Codes Amendments

Approved additions to the
2018 NC State Building Codes

**Brought to you by:
The Construction Institute of Charlotte**

FIGURE R4603.6(d)
CORNER PILE CONNECTION

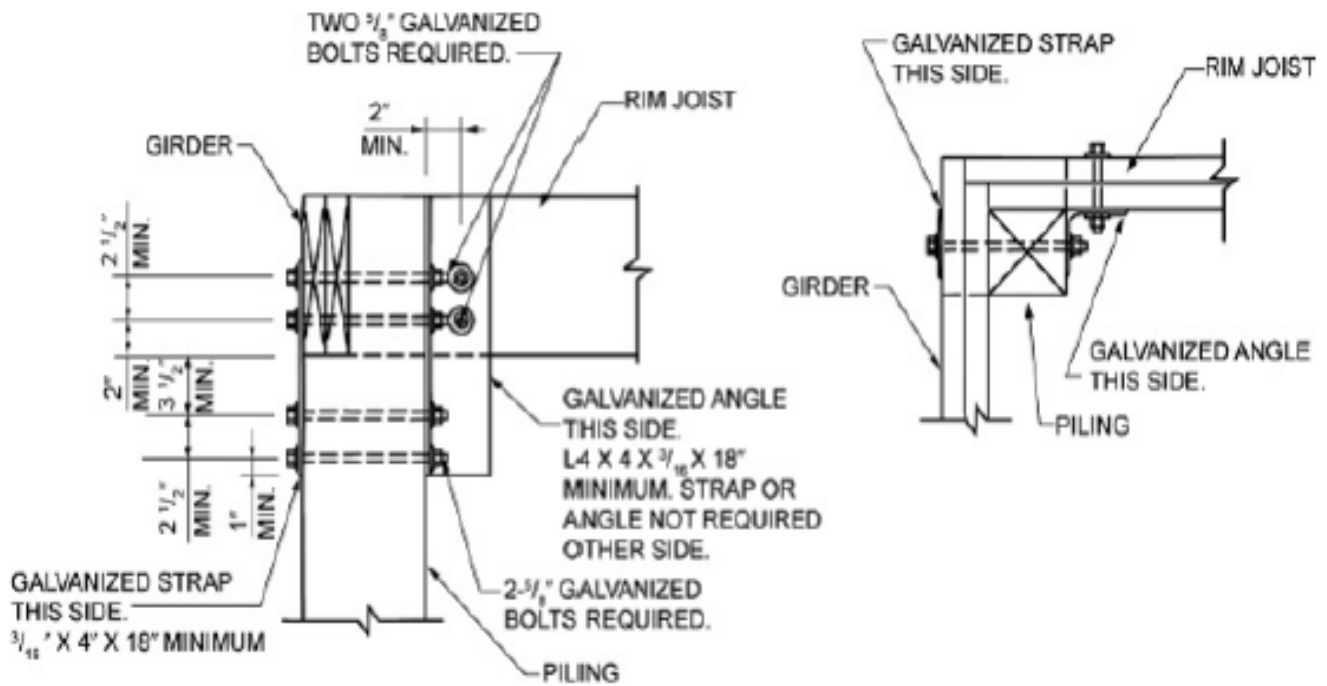
R4603.6.1 Tying at corners. At corners, girders shall be connected to the pile with a minimum 3/16 × 4 × 18-inch (5 × 102 × 467 mm) hot dip galvanized strap bolted with two 5/8 inch (15.9 mm) galvanized through bolts on the exterior and a minimum L4 x 4 x 3/16 x 1'-6" (102 × 5 × 467 mm) galvanized steel angle bolted with two 5/8 inch (15.9 mm) galvanized through bolts on the interior in accordance with Figure R4603.6(d), or with a minimum of (2) 3/16" x 4" x 18" (5x102x467 mm) hot dip galvanized straps installed on the outside of the girders with fasteners per Table R4603.6.1 and in accordance with Figure R4603.6 (e).

**FIGURE R4603.6(b)
TOP MOUNTED GIRDER**

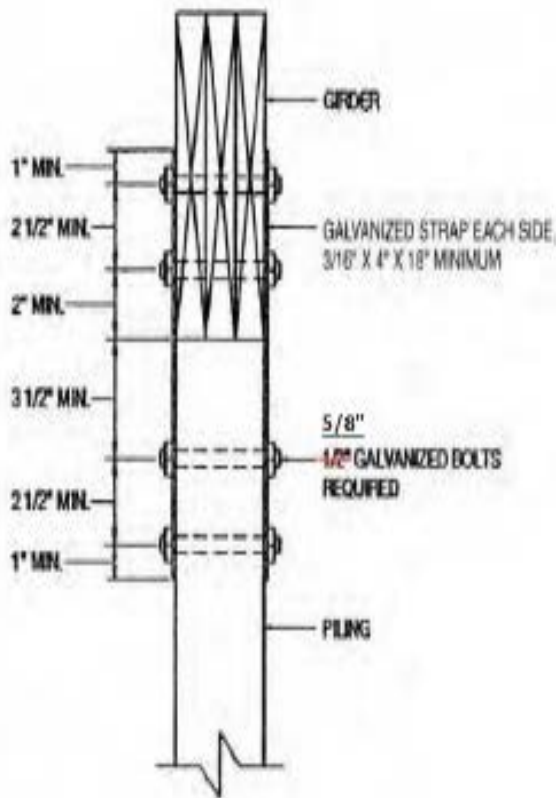
Revise Figures as follows:

**FIGURE AM109.1(2)
KNEE BRACING**

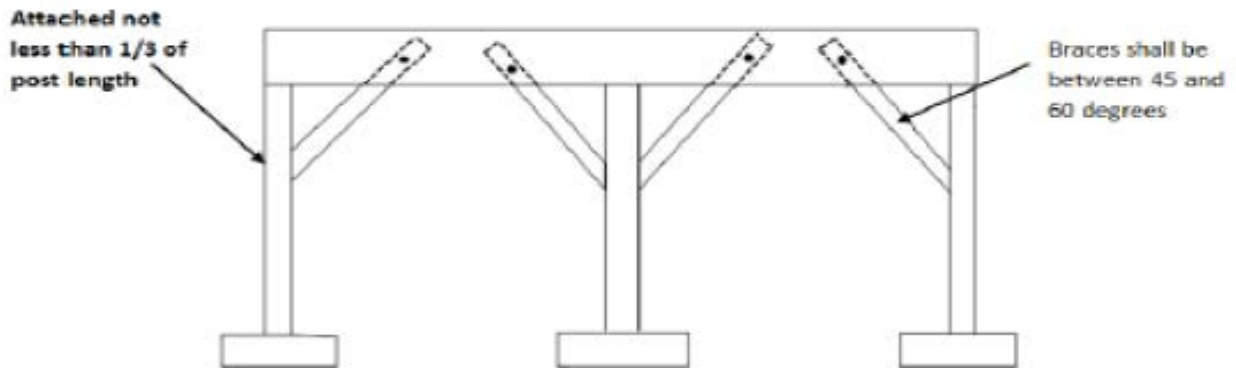
4x4 wood knee braces are permitted to be provided on each column in both directions for freestanding decks or parallel to the structure at the exterior column line for attached decks per Figure AM109.1(2). The knee braces shall attach to each post at a point not less than 1/3 of the post length from the top of the post, and the braces shall be angled between 45 degrees (0.79 rad) and 60 degrees (1.05 rad) from the horizontal. Knee braces shall be bolted fastened to the post and the girder/double band in accordance with one 5/8 inch (16 mm) hot dip galvanized bolt with nut and washer at both ends of the brace of the methods shown in Table AM109.1, as shown in Figure AM109.1(2).

**FIGURE AM109.1(4)
CROSS BRACING**

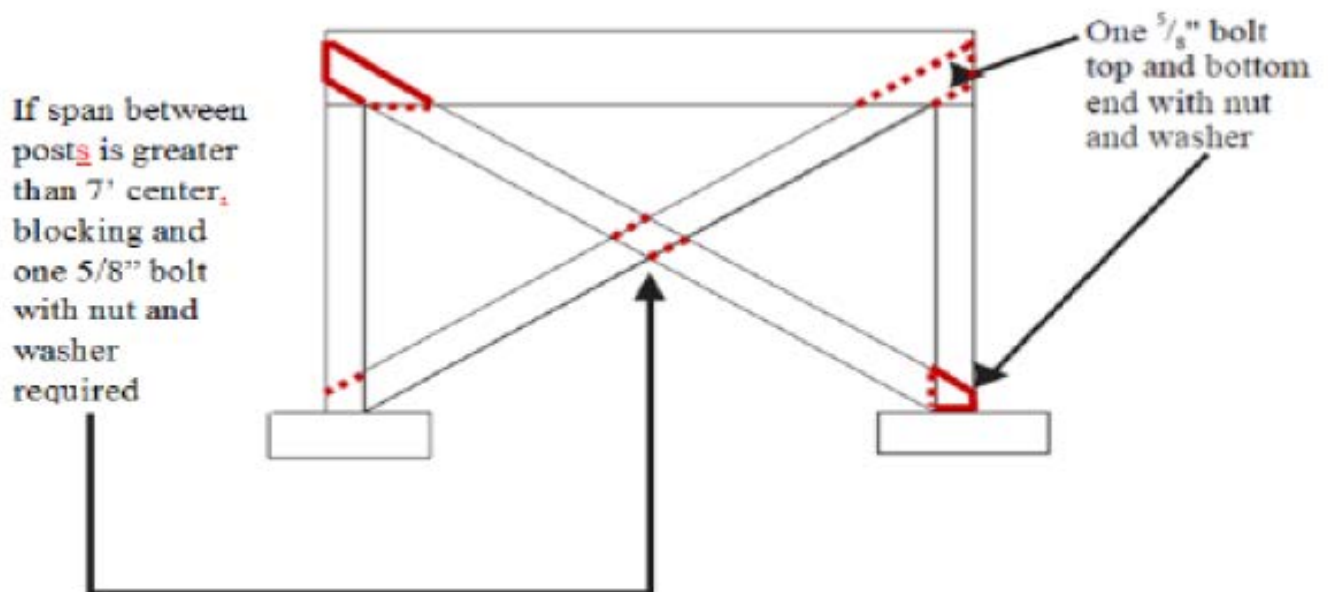
2x6 diagonal vertical cross bracing is permitted to be provided in two perpendicular directions for free standing decks or parallel to the structure at the exterior column line for attached decks. The 2x6 bracing shall be attached to the posts with one 5/8 inch (16 mm) hot dip galvanized bolt with nut and washer at each end of each bracing member per Figure AM109.1(4).
